Wollongong Local Planning Panel Assessment Report | 10 April 2019

WLPP No.	Item No.3
DA No.	DA-2017/830
Proposal	Additional long term site and amended community layout plan
Property	Oasis Caravan Park, 140-146 Windang Road, WINDANG NSW 2528
Applicant	Steven Fripp – I & H Investments P/L
Responsible Team	Development Assessment and Certification - City Centre Team (NL)

ASSESSMENT REPORT AND RECOMMENDATION

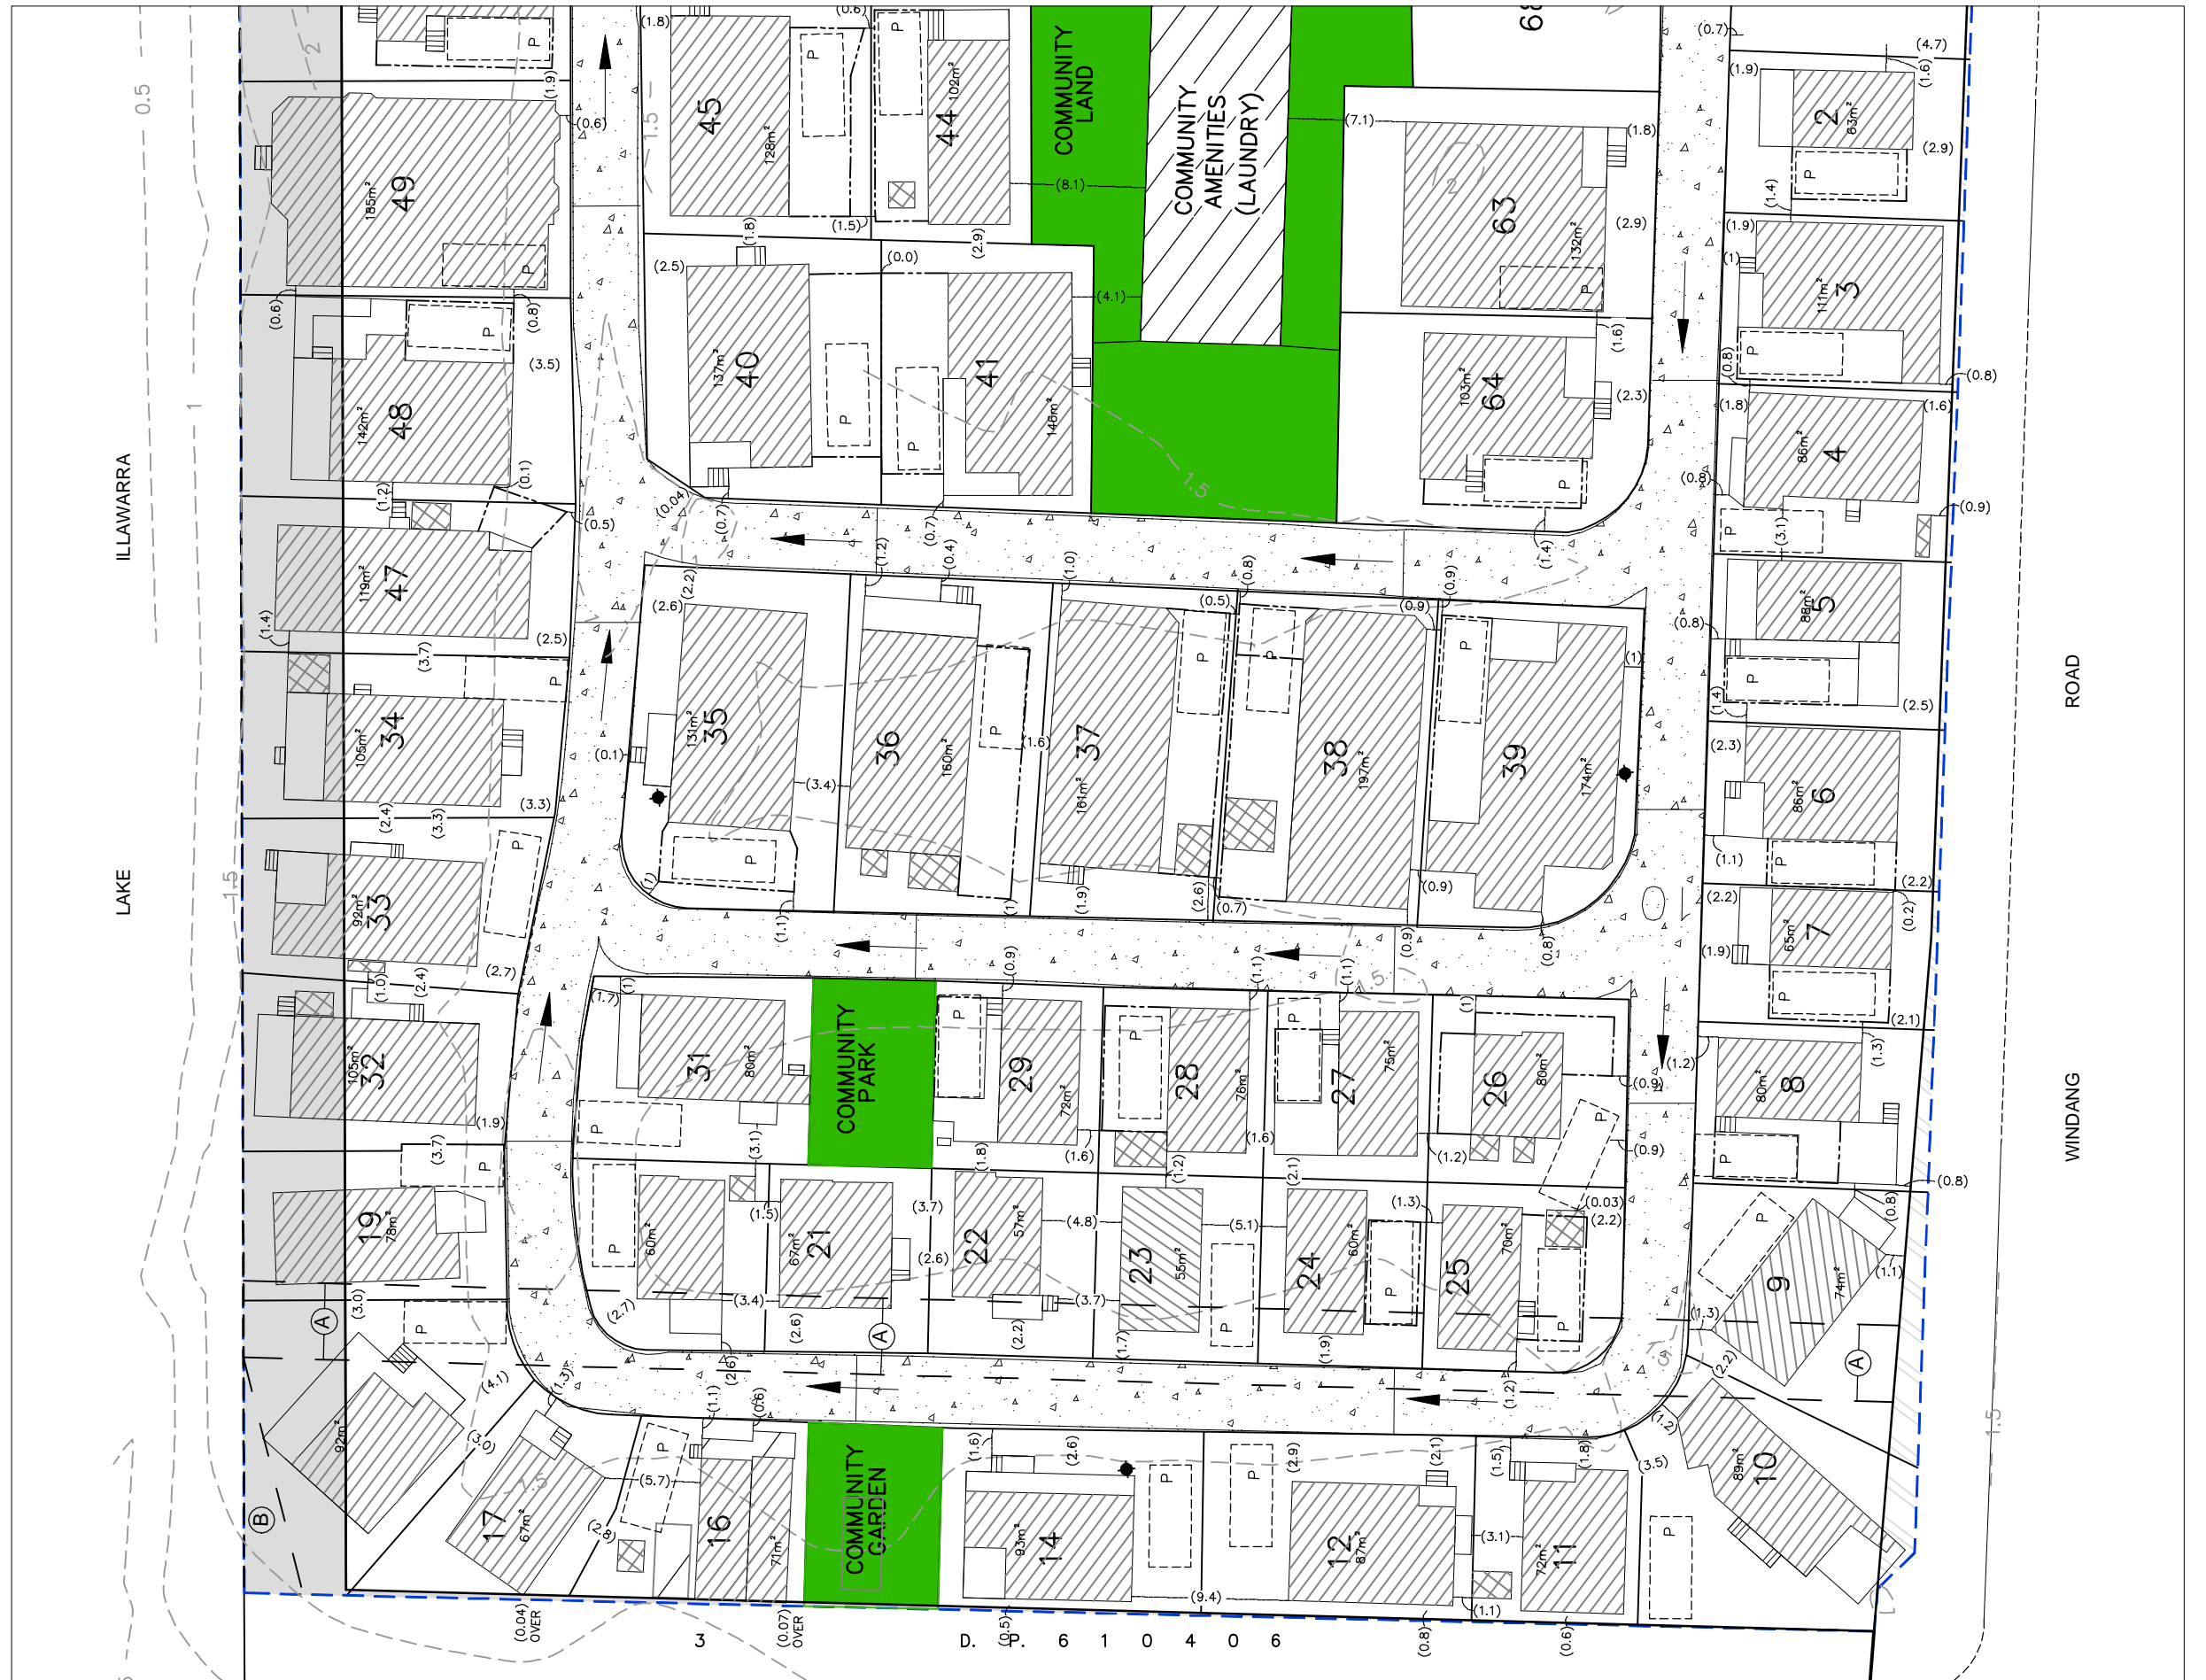
- The caravan park encroaches into the adjoining SP2 road corridor. Caravan parks are not a permitted use in that zone.
- The Bushfire Risk Assessment dated 7 July 2017 prepared by Set Consultants Pty Ltd recommends establishment of a 15m wide asset protection zone on Council owned land through a Plan of Management. This was reviewed by the RFS and supported as reflected in their Bushfire Safety Authority at Attachment 8. However, registering of an asset protection zone through such a mechanism is not supported by Council. Rather, an asset protection zone for a commercial operation should be achieved wholly within the boundaries of the site.
